AGENDA

President and Board of Trustees
Village of Arlington Heights
Board Room

November 21, 2016

- D. Marathon Gas Station - 1706 W. Northwest Highway - PC#16-016 Special Use for Auto Service Station

SCALE
AS SHOWNDRG.NO. **A1**

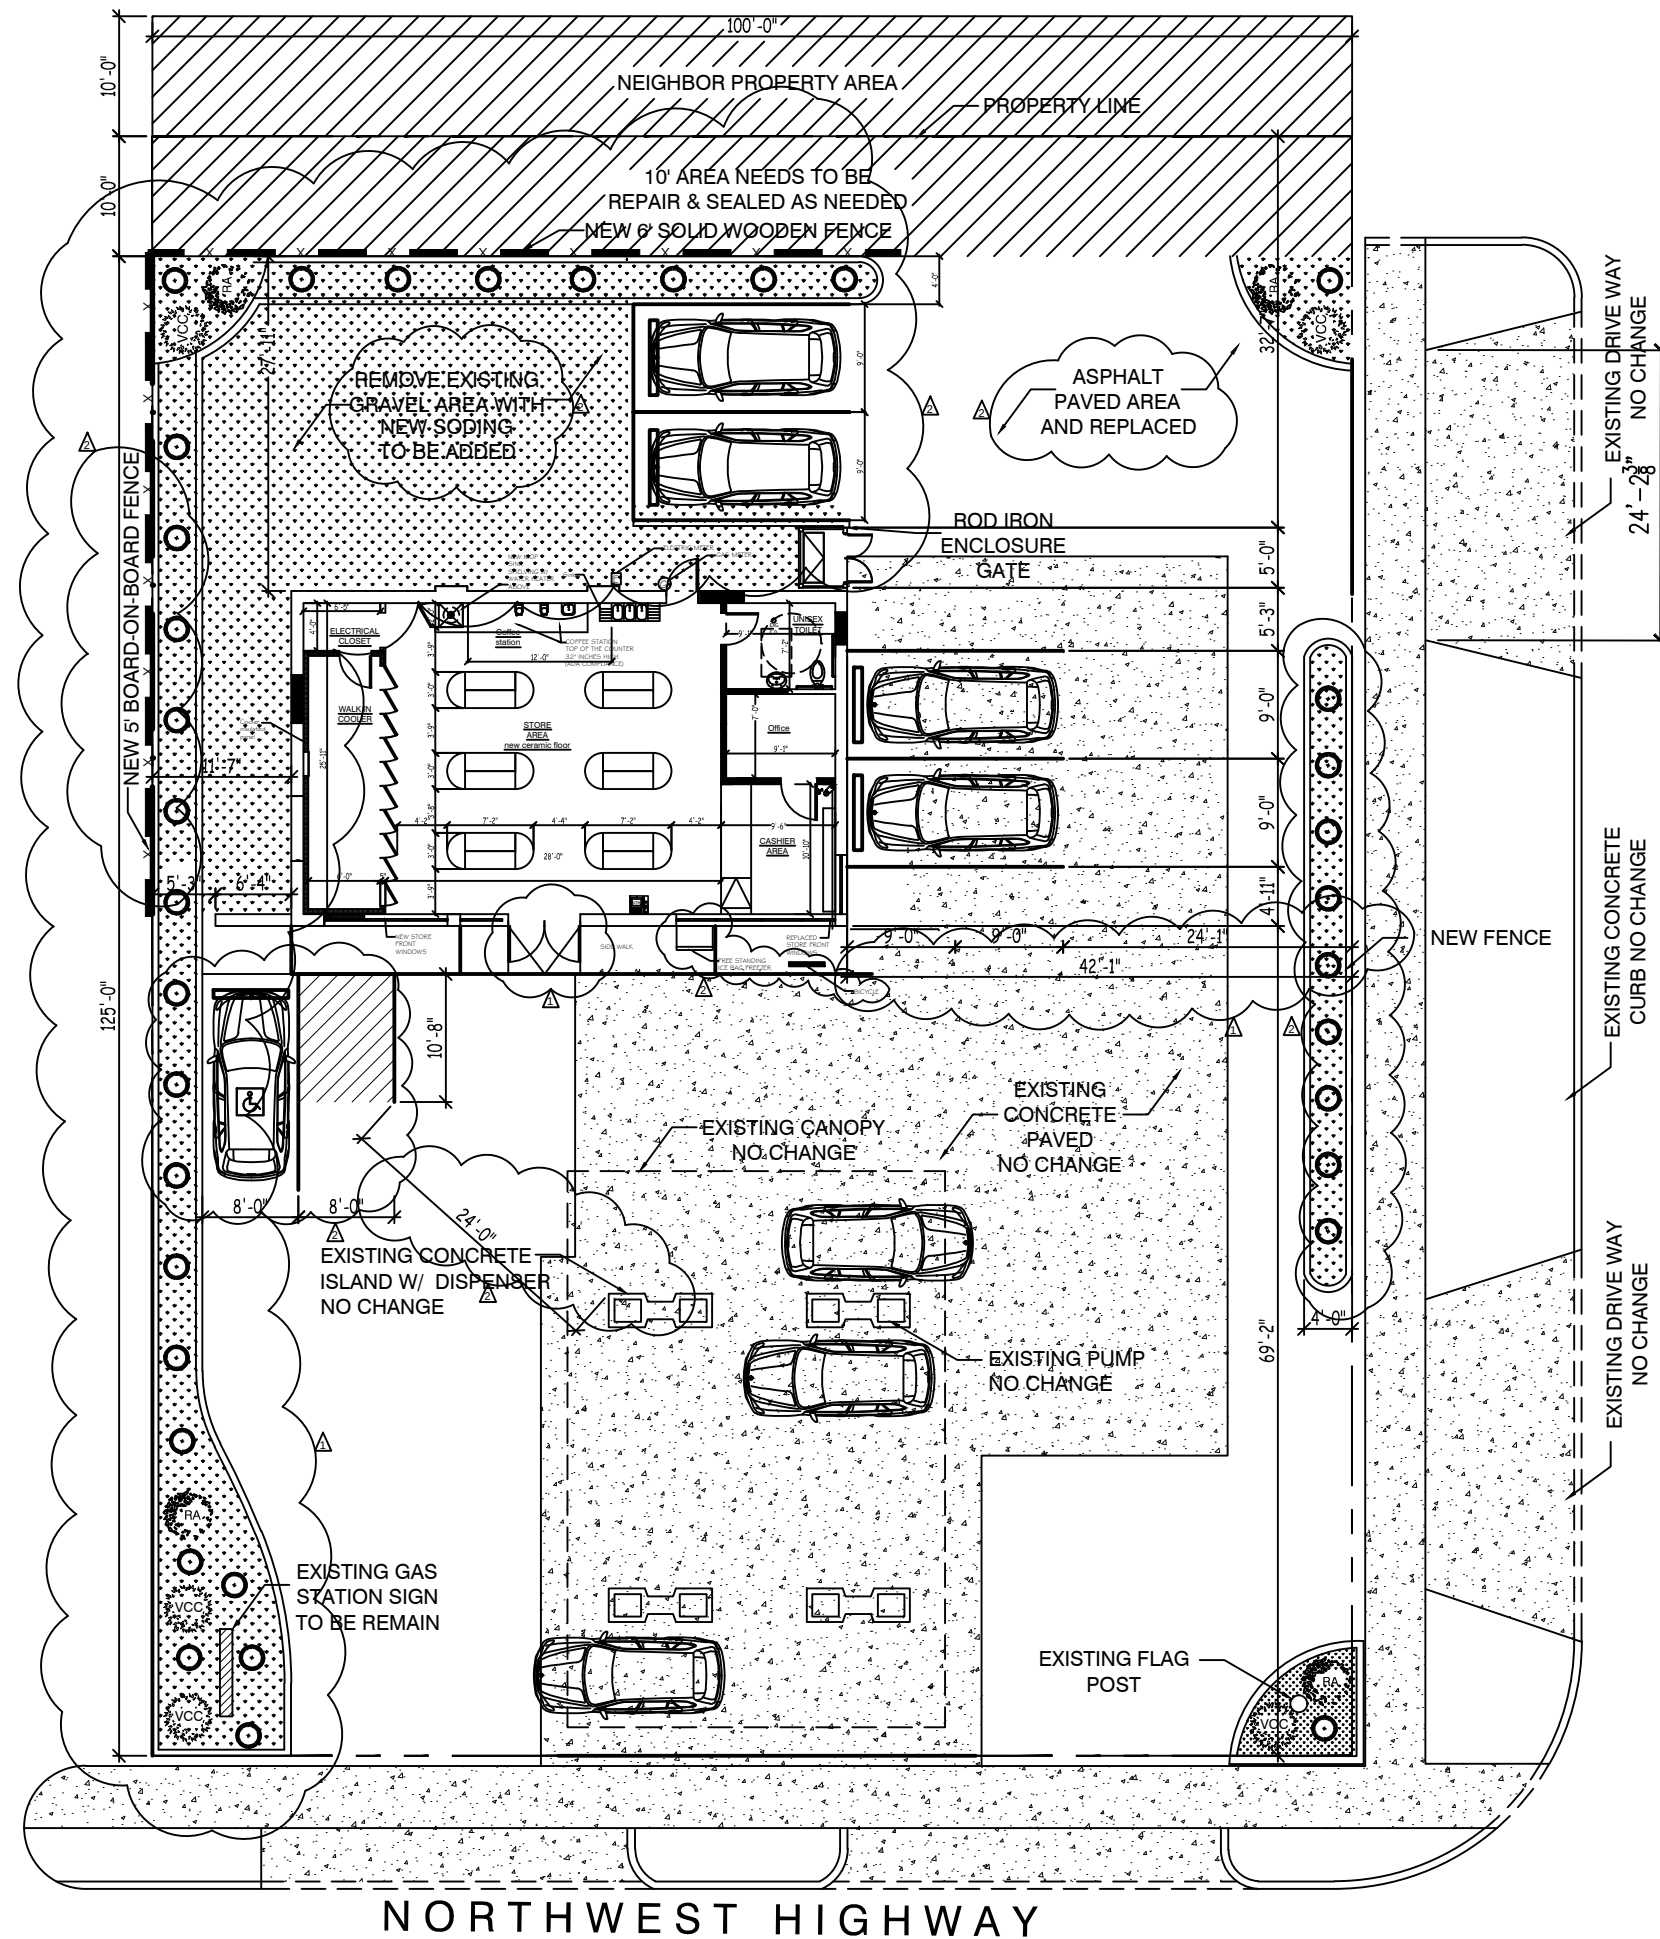
9. The proposed 8' tall fence along the rear of the property must be reduced in height so as not to exceed 6'. Additionally, this fence should be a solid privacy fence so as to provide a full screen (i.e. spaces between the fence boards are not allowed). Please revise this graphic on the site plan. **SEE ATTACH DWG A2, REVISION-2 WITH DETAIL.**

10. The fencing in the front of the property along Northwest Highway and along Race Avenue is not allowed. **WE REMOVED.**
11. The fence along the side of the property (west) should be revised so that it is a 5' tall board-on-board fence. The proposed 8' tall fence in this location is not allowed. Please provide a detail for the 5' tall solid board-on-board fence, or add a note to the site plan indicating that it will be a board-on-board fence. **SEE THE NOTE ON DWG A2, REVISION-2**

13. Handicap parking spaces are only required to be 8' wide with an 8' wide striped access pathway. The proposed handicap space appears to be 9' wide with a 9' wide access pathway. Please reduce the width of this space to be 8' wide with an 8' wide striped access aisle, which will allow for greater distance between the pump island and the edge of the parking space. Additionally, we recommend removing the parking space on the side to provide additional drive aisle space (see attached graphic). **SEE ATTACH DWG A2, REVISION-2.**

15. Add a note to the "Asphalt Paved Area" indicating that the asphalt in this area will be removed and replaced (see attached graphic). **SEE ATTACH DWG A2, REVISION-2.**

23. The drive aisle, currently shown as 11'9" and in-between the handicap space and the existing pump, is required to be no less than 24' in width. Please revise the plan to create a 24' wide drive aisle or request a Variation. SEE ATTACH DWG A2, REVISION-2.

- 1) Overall the landscaping is minimal. Along the north property line, replace the sedum with a deciduous shrub that is salt and drought tolerant and planted three feet on center. In addition, it is recommended that the width of the planting bed be increased from 2.5 feet to 3 feet. SEE ATTACH DWG A2, REVESION-2.

- 2) Along the west property line consider ornamental grasses in place of the proposed sedum. The ornamental grasses should be planted approximately 2 feet on center. SEE ATTACH DWG A2, REVESION-2.

1 ELEVATION - PROPOSED TRASH ENCLOSURE WITH GATES
N.T.S.

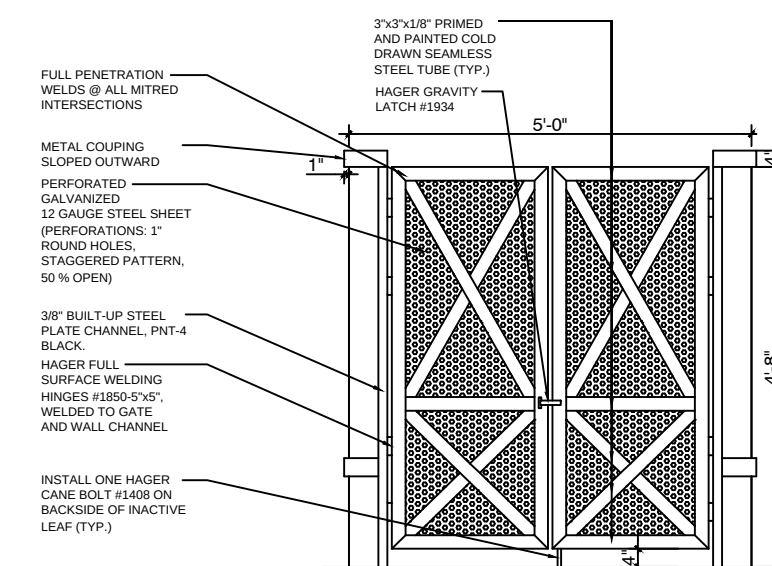
21. Information on the materials of the walls of the dumpster enclosure is required. The walls should be brick to match the materials of the building. No information on the walls of the dumpster enclosure have been provided. **ROD AND IRON SEE THE DETAIL ON DWG A2, REVISION-2.**

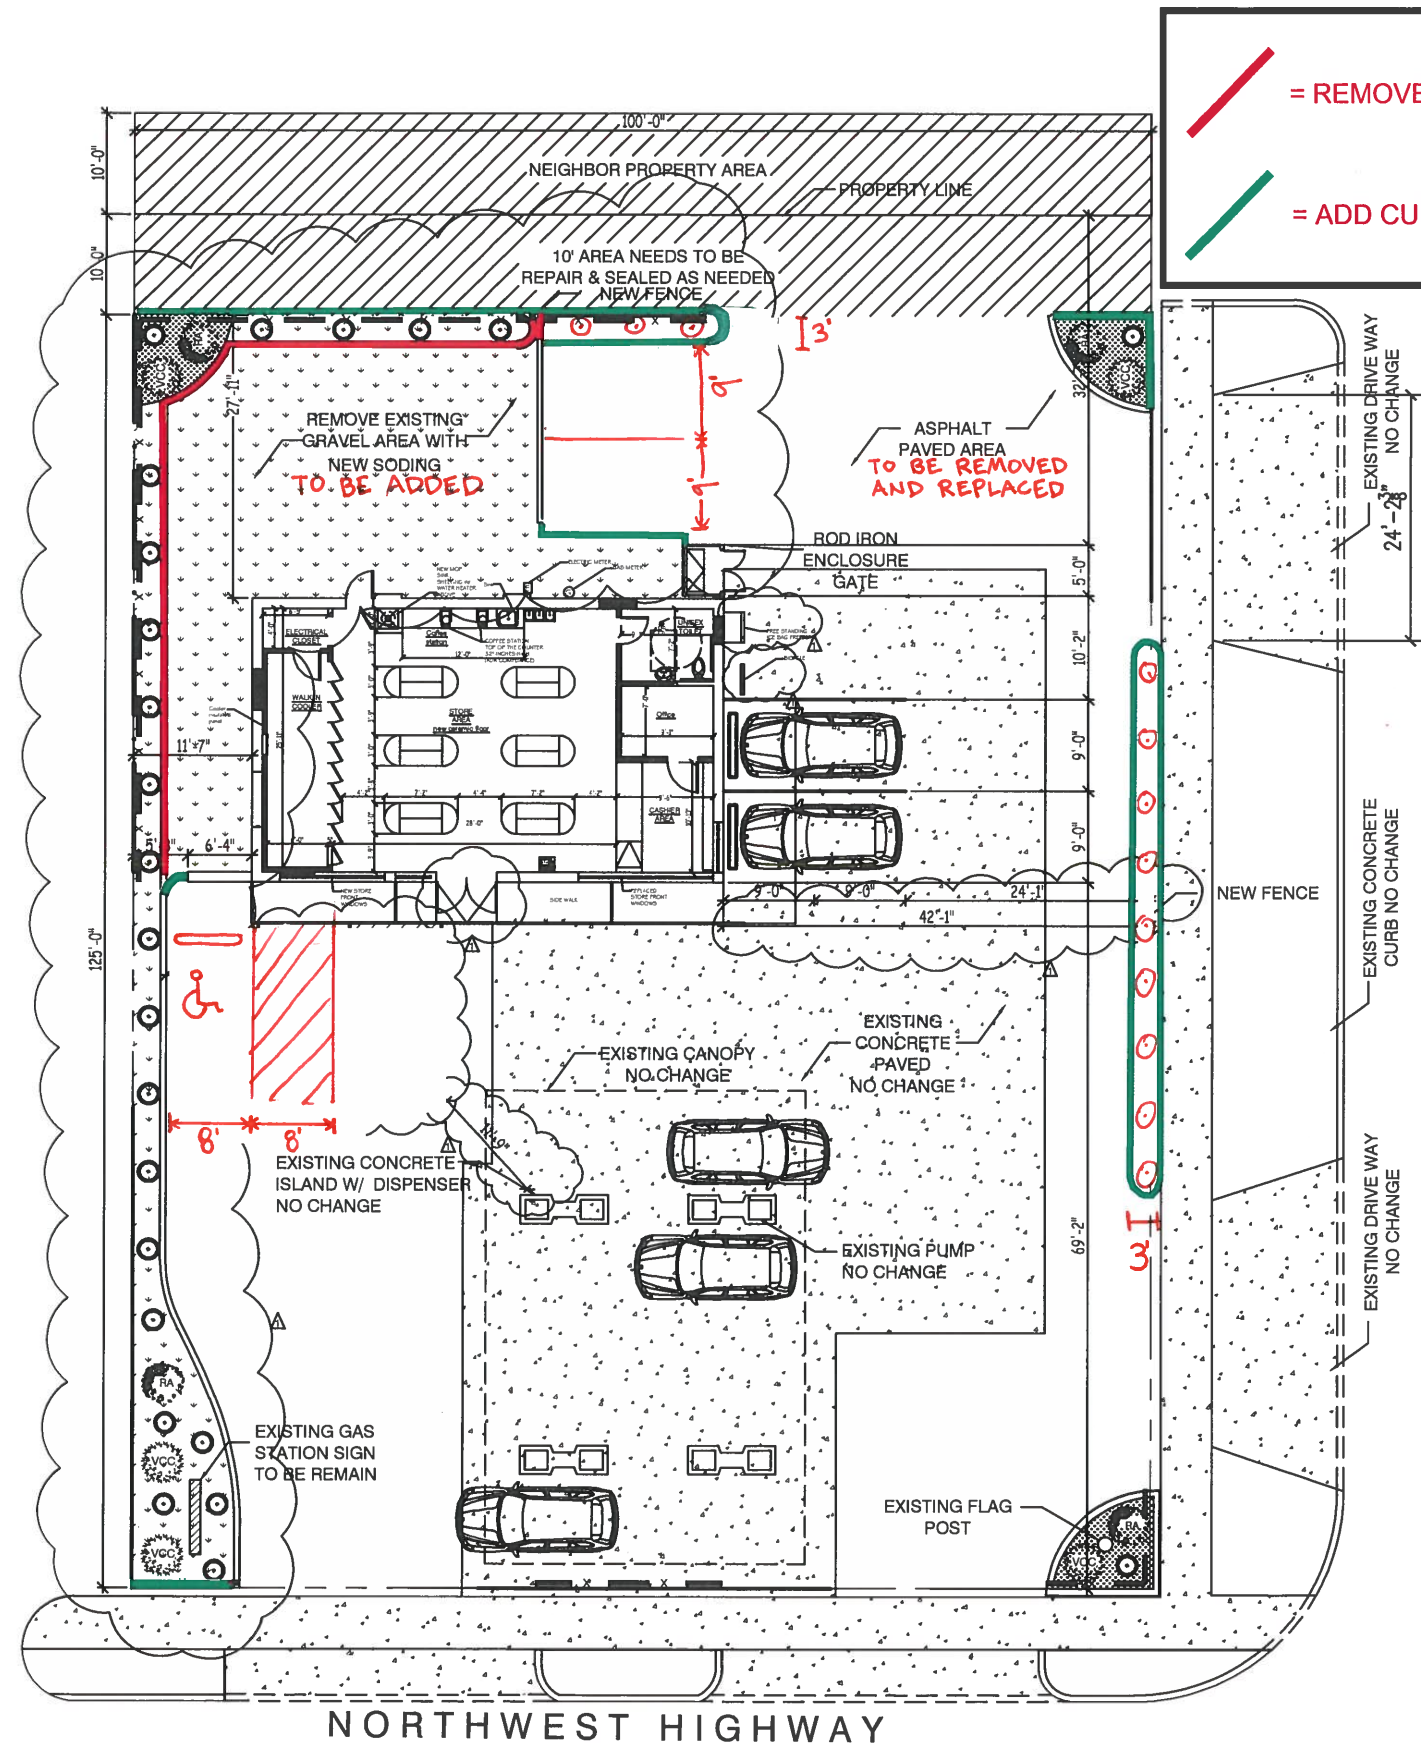
15. Add a note to the "Asphalt Paved Area" indicating that the asphalt in this area will be removed and replaced (see attached graphic).
16. Add a note to the "Remove Existing Gravel Area With New Sodding" to clarify that the new sodding will be

added (see graphic).

17. Curbs must be provided around edges of the landscape beds. The curbs around the landscape beds that abut the newly sodded area should be removed (see attached graphic).

18. A 9-foot wide curbed island with a 4-inch caliper shade tree is required at the end of each row of parking row. Since this requirement has not been met, a Variation is required. Staff supports this Variation due to the small size of the site, however, please provide the written justification as outlined in #22 below.

added (see graphic). SEE ATTACH DWG A2, REVISION-2.
